**CITY OF BOULDER
PLANNING BOARD MEETING AGENDA**

CITY OF BOULDER
AGENDA ITEM PLANNING BOARD
MEETING DATE: February 6, 2014

CONCEPT PLAN REVIEW AND COMMENT: Request for public and Planning Board comment on a proposal for the redevelopment of 1750 28th Street. Proposed to include reuse of existing James Travel Building along with residential, commercial and office space.

DATE OF COMMENTS: **December 6, 2013**
CASE MANAGER: **Elaine McLaughlin**
PROJECT NAME: **The James**
LOCATION: **1750 14TH ST**
COORDINATES: **N03W06**
REVIEW TYPE: **Concept Plan Review & Comment**
REVIEW NUMBER: **LUR2013-00061**
APPLICANT: **KYLE MCDANIEL**
DESCRIPTION: **CONCEPT PLAN REVIEW AND COMMENT: Re-development of site to include 43 attached apartment units in 33,634 s.f. and 10,054 s.f. of existing commercial space and 11,629 of new office space.**

Figure 11: Location of 100 year flood zone in relation to property

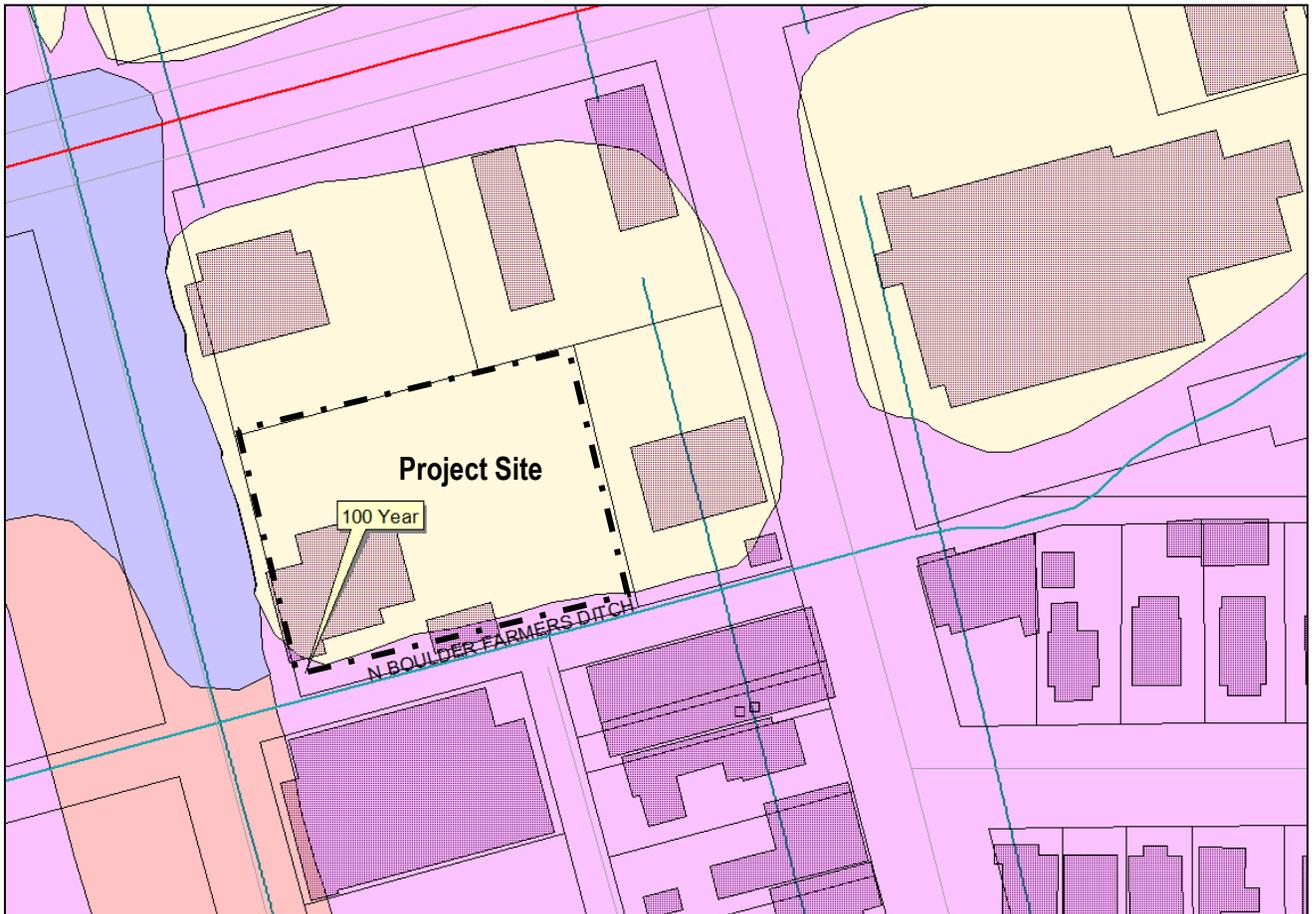
The property is located adjacent to the North Boulder Farmer's Ditch and a small area of 100 year flood zone is located on the property as shown in Figure 11. Because of the flood context, the site must be developed in compliance with Section 9-3-3 of the Boulder Revised Code, 1981 (*BRC*). A floodplain development permit demonstrating compliance with floodplain development regulations will be required at the time of building permit. The City of Boulder has adopted modifications to the floodplain development regulations which will become effective on March 1, 2014. The revisions include a clarification of the standards for development of a mixed use structure. The ordinance will require that any person making a substantial modification or a substantial improvement to an existing mixed-use structure shall flood proof or elevate the lowest floor, including the basement of the entire structure and shall elevate all residential and lodging units within the structure to or above the flood protection elevation.

Other environmental considerations include a number of existing trees that align the ditch that such as box elder and willow, that should be preserved with any extension of the multi-use path. There are also existing established oak trees along the street frontage on 14th Street that are valued as a species and should be preserved. Refer to the Landscape comments regarding preservation of on-and off-site trees near the area planned for construction.

Figure 3:
**Proposed East Elevation of the Building Placed into the Existing Context
 Looking West from 15th Street with Historic McAllister Building in Foreground**

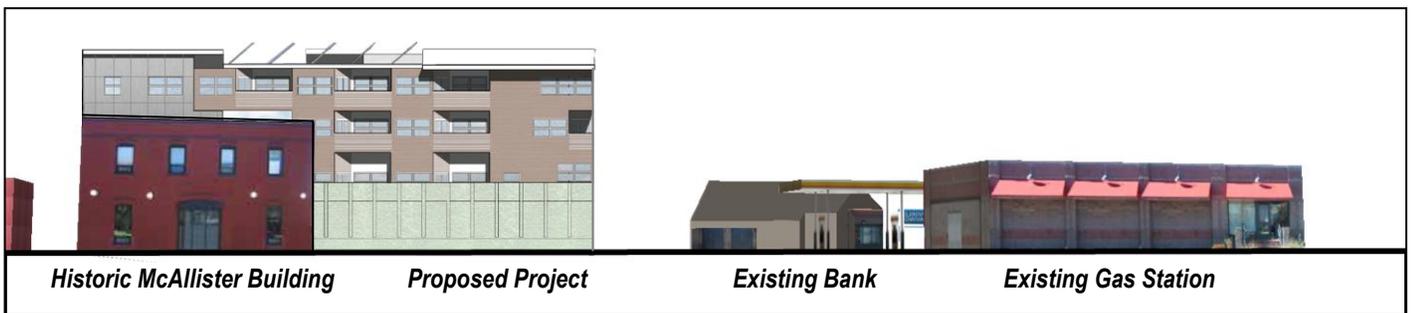
- g. To a similar extent, the views of the building from the east, along 15th Street as shown below in Figure 3 will also be pronounced in the interim prior to redevelopment of the adjacent properties. Precedent images of how the green walls will be implemented would be helpful in understanding the appearance of the building during the period of time from the existing context to the future redevelopment of the surroundings.

Figure 5: Location of 100 year flood zone in relation to property

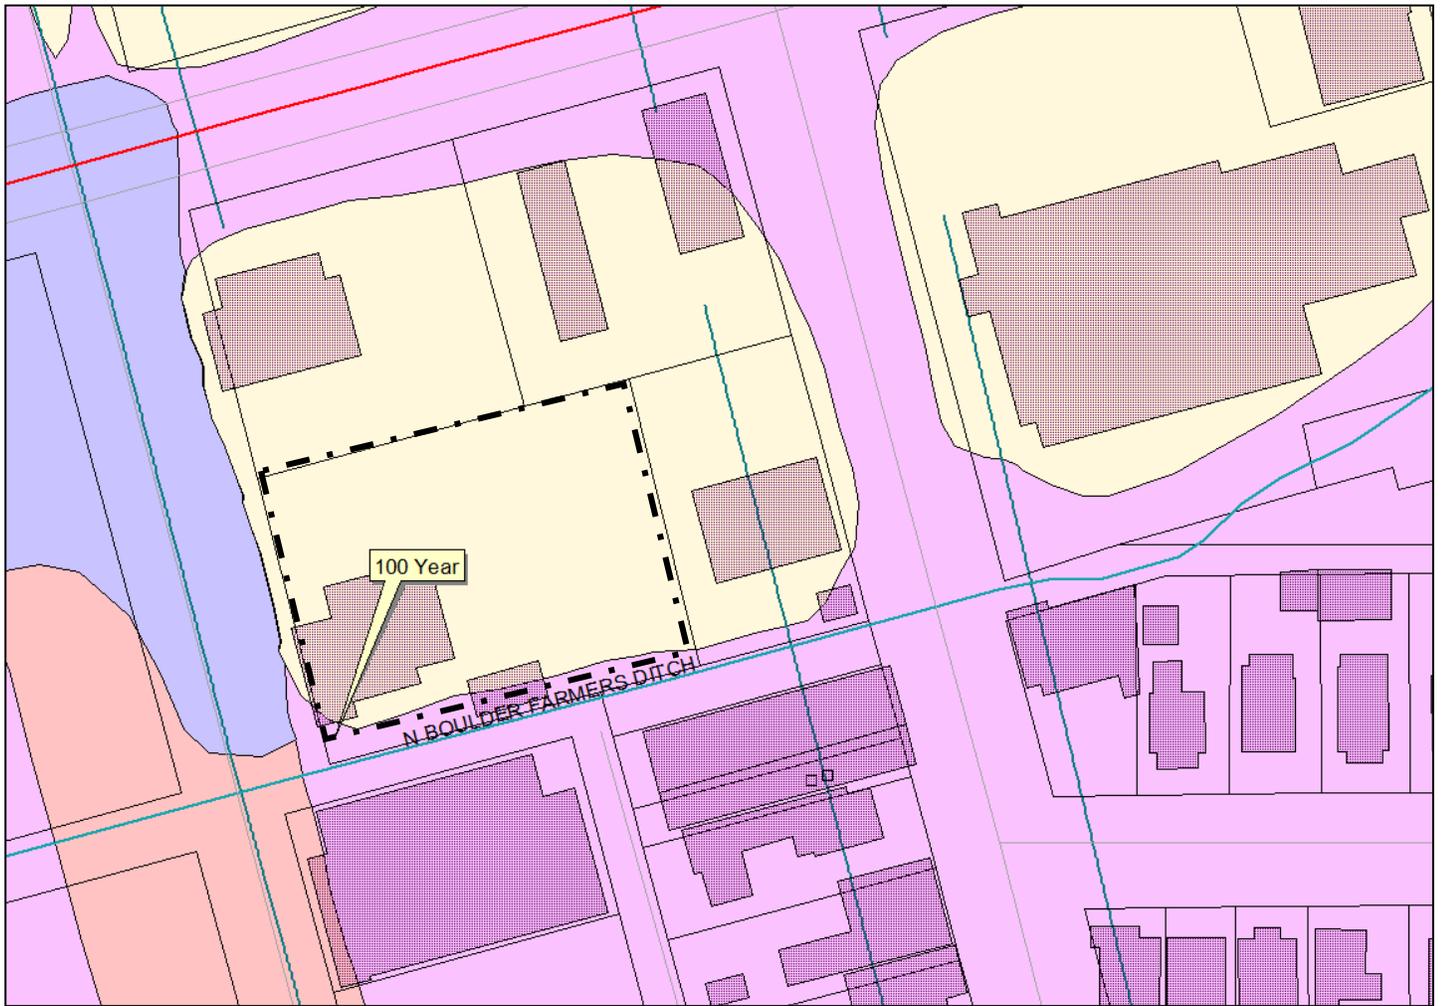
The property is located adjacent to the North Boulder Farmer's Ditch and a small area of 100 year flood zone is located on the property as shown in Figure 5. Reference the Flood Control comments regarding mitigations for locating within the 100-year flood zone.

There's a number of existing trees that align the ditch that include Boxelder and Willow that should be preserved with any extension of the multi-use path. There are also existing established oak trees along the street frontage on 14th Street that are valued as a species and should be preserved. Refer to the Landscape comments regarding preservation of on-and off-site trees near the area planned for construction.
